TRACKSIDE GARDENS

WILSON EAST

Town Planning Application - RFI Response

Project Name 110 Wilson Street
Project Number 00013261
Project Address 110 Wilson Street
Moonee Ponds VIC 3039

WILSON EAST
Shadow Studies - June
Solstice

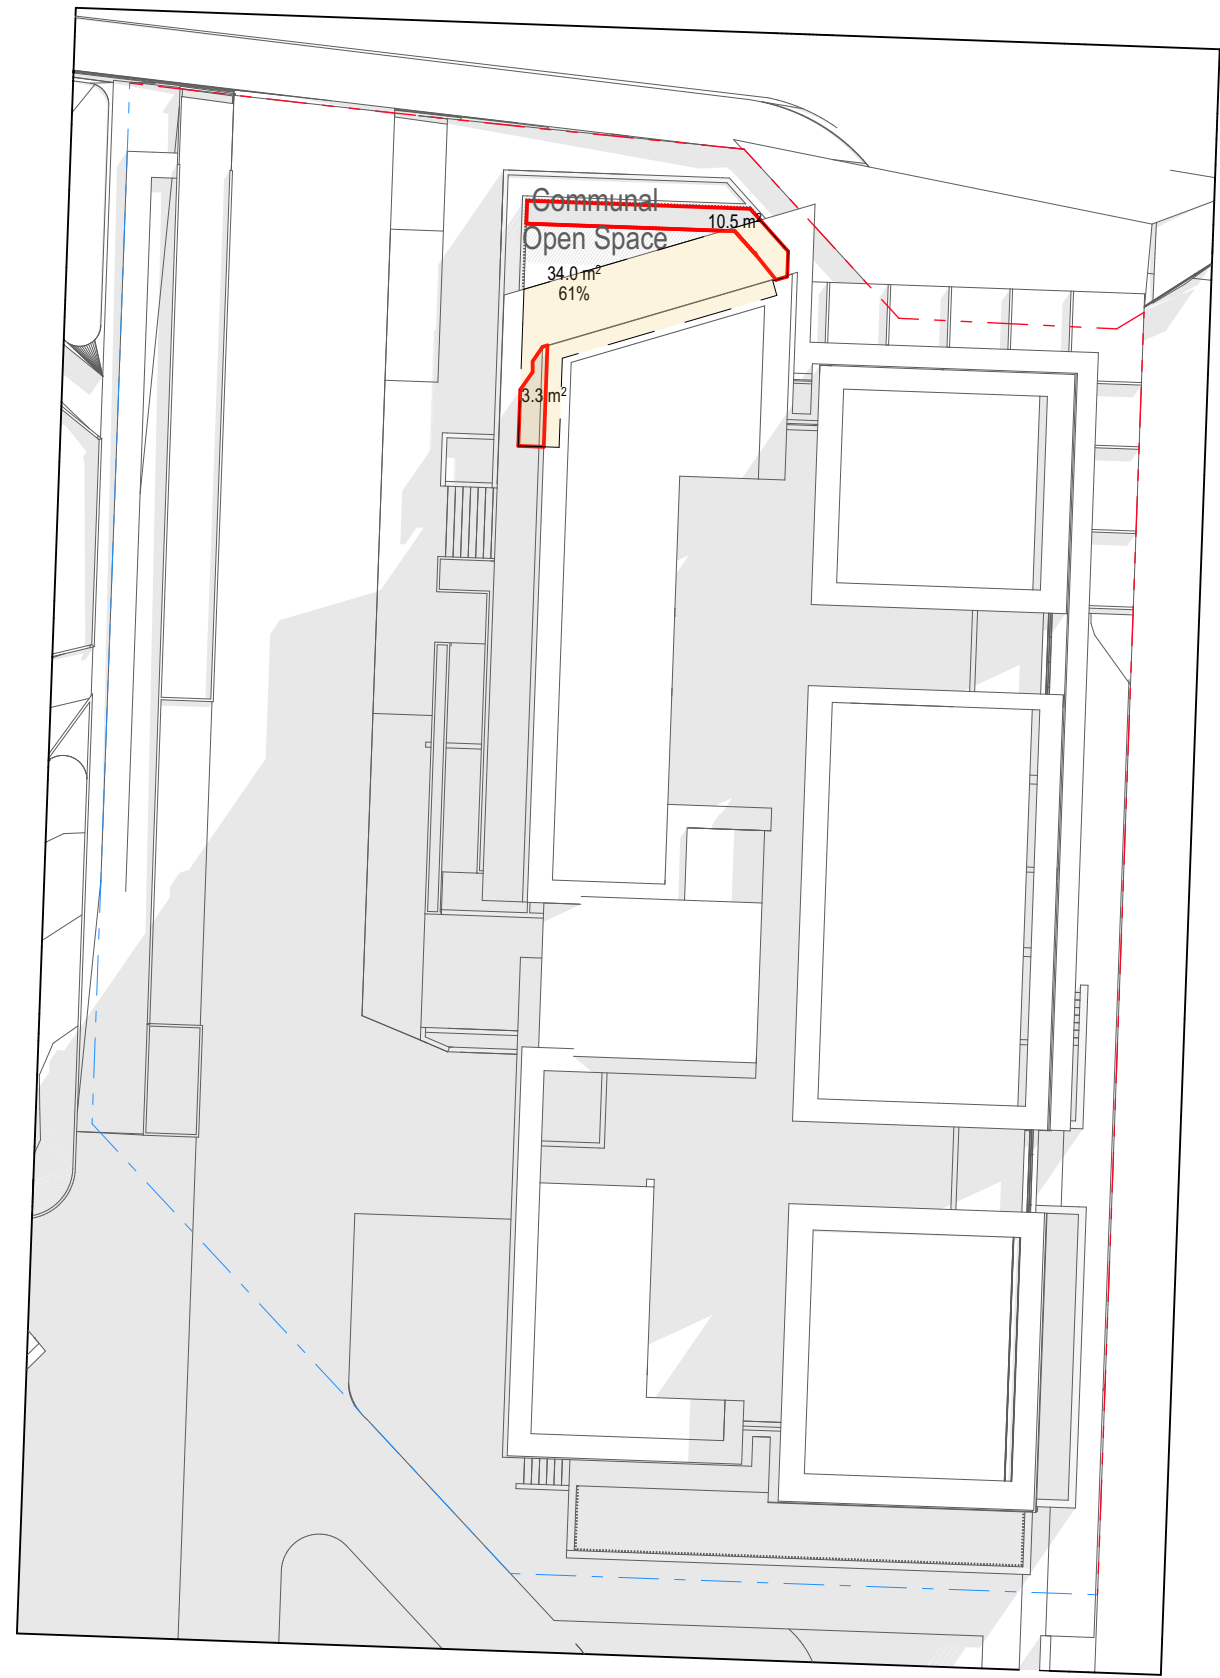
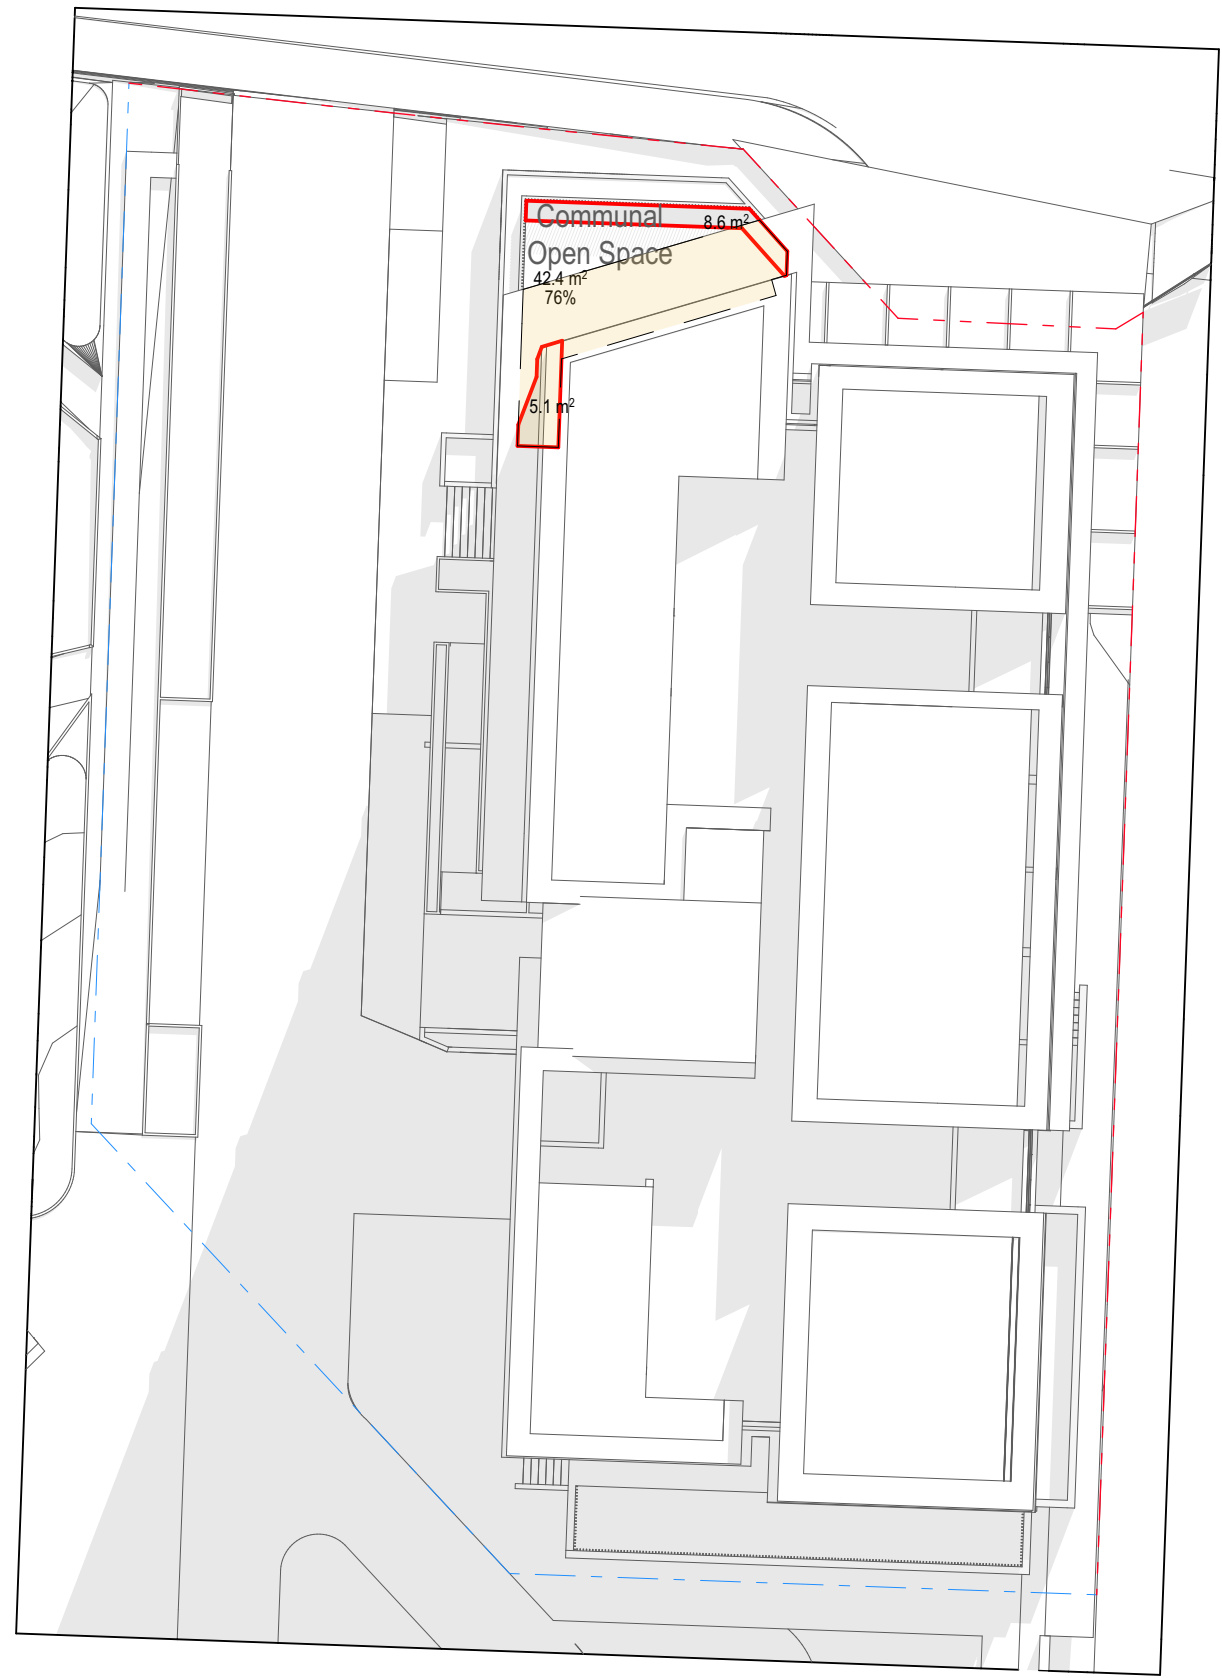
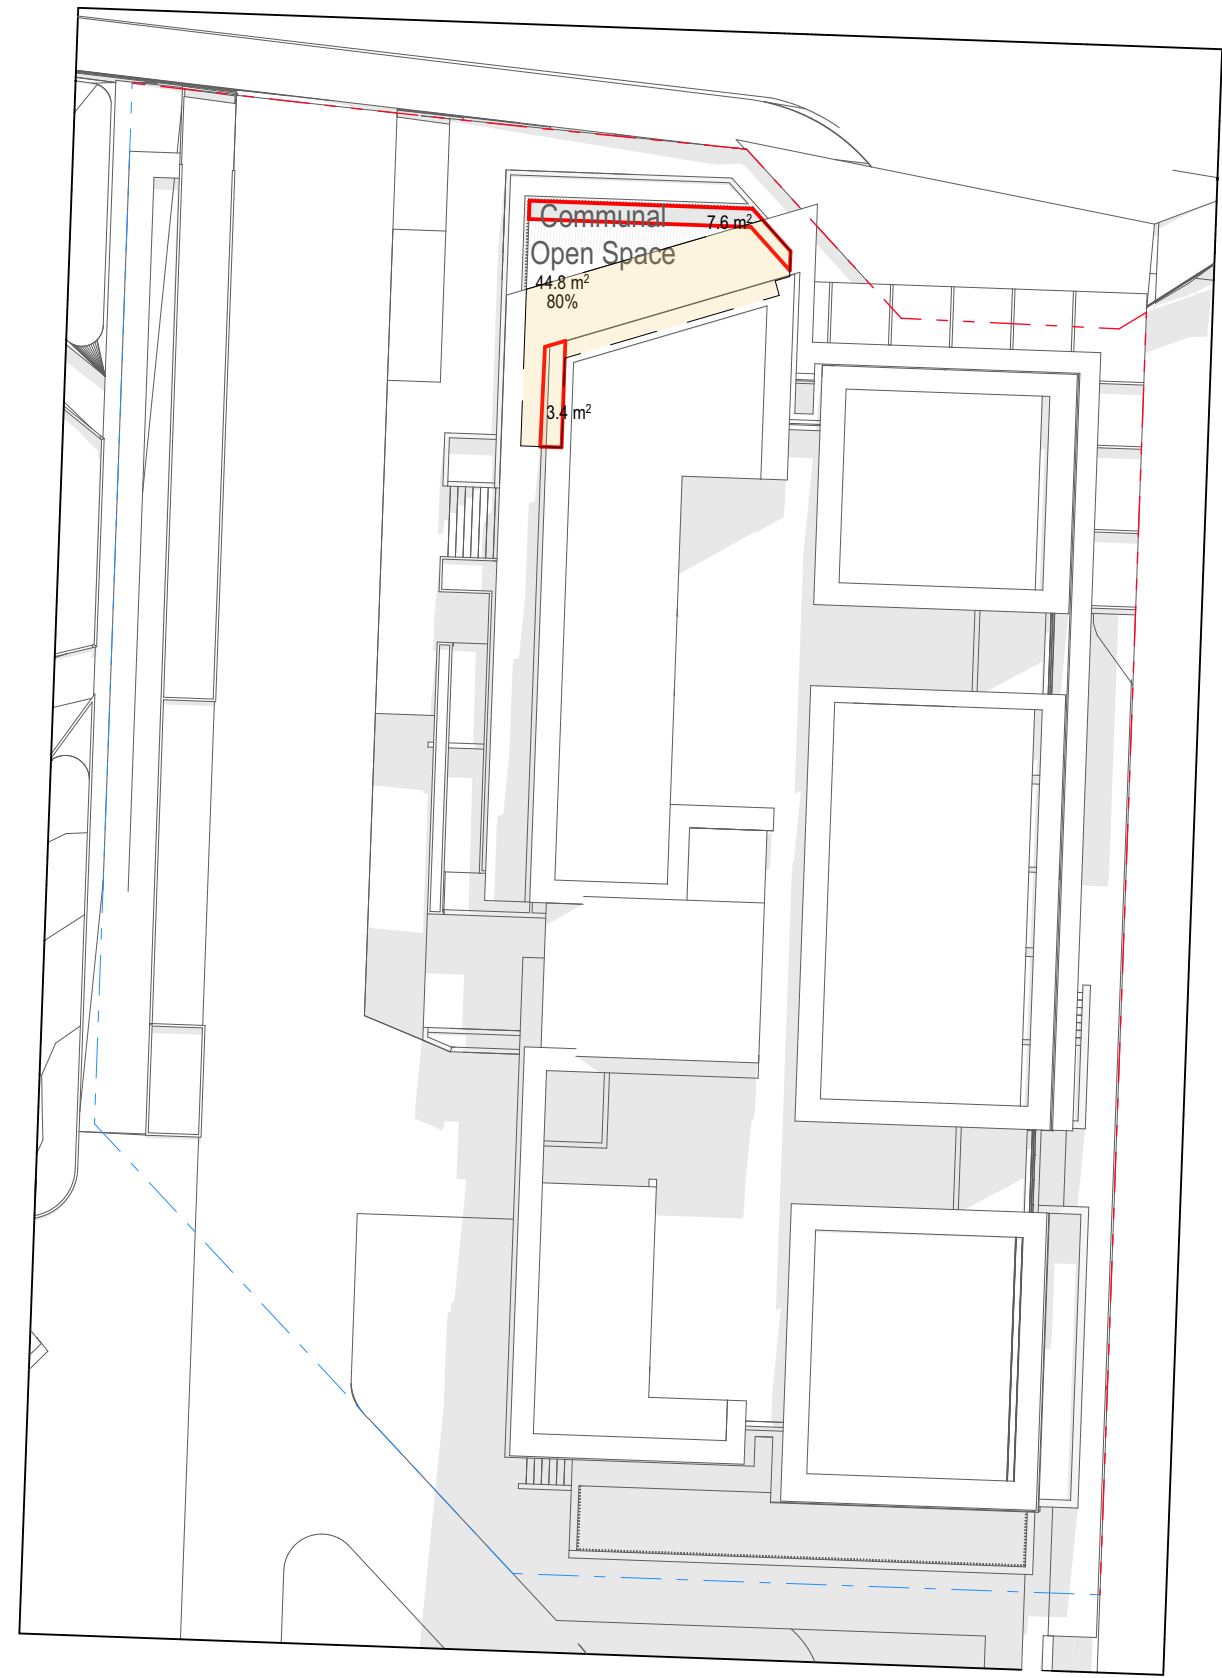
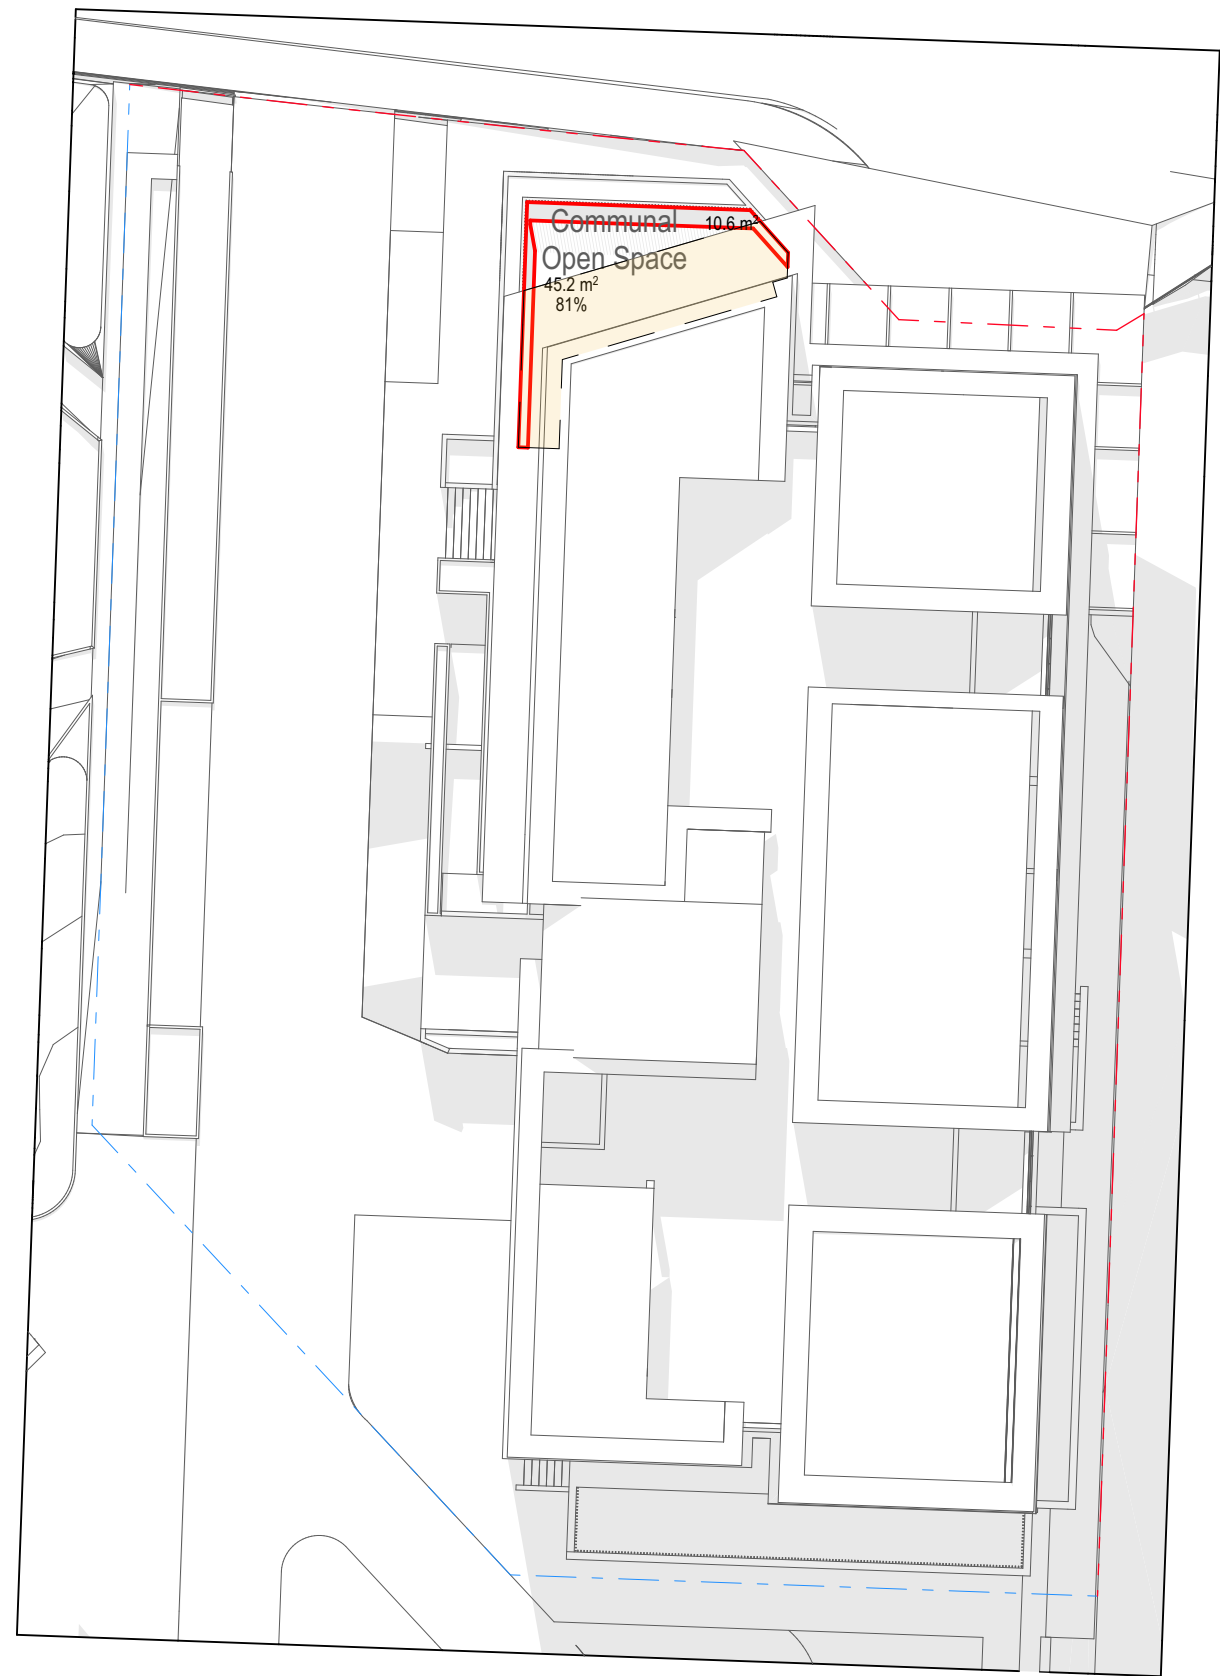
PA2604323 SECTION 54(1) RPI MATTERS
4.
b) All wind mitigation devices required per the recommendations of the Environmental Wind Speed Assessment, including details of materiality, height and cross-sections if necessary.
